# **MEMO**

## PLANNING AND COMMUNITY DEVELOPMENT

Re: Certificate of Appropriateness- 124 W Wisconsin

### **Proposed:**

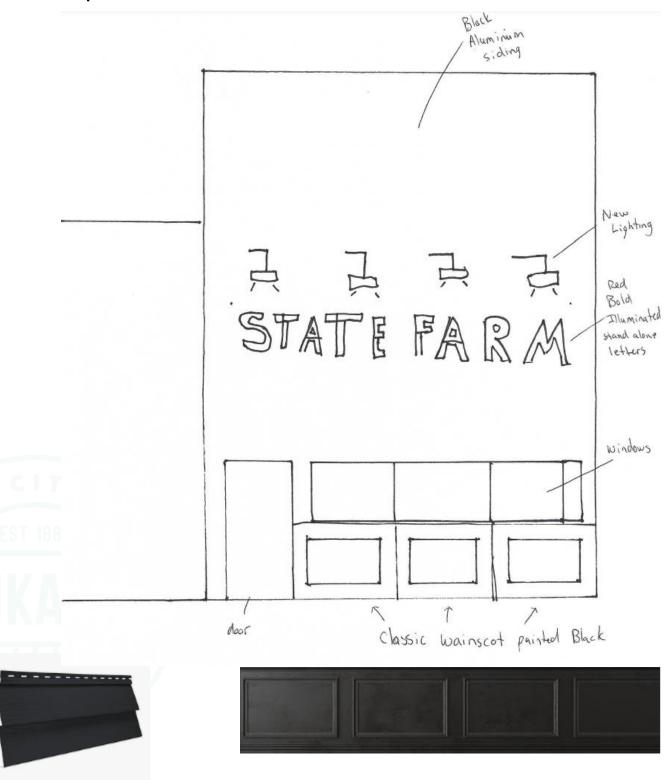
124 W Wisconsin is preparing to replace the Façade of the building. The materials to be used is aluminum siding and wainscoting. The existing façade is a vinyl siding with a thin brick below the display windows.

The new owner is willing to use brick in the same area that the existing thin brick is if RACK would prefer. Wainscoting is a classic historic feature that can be seen on other buildings in the downtown area such as on 112 W Wisconsin and having a variety of looks in the downtown area is also an item worth discussing.

Recommendation:

To Grant a Certificate of Appropriateness to 124 W Wisconsin
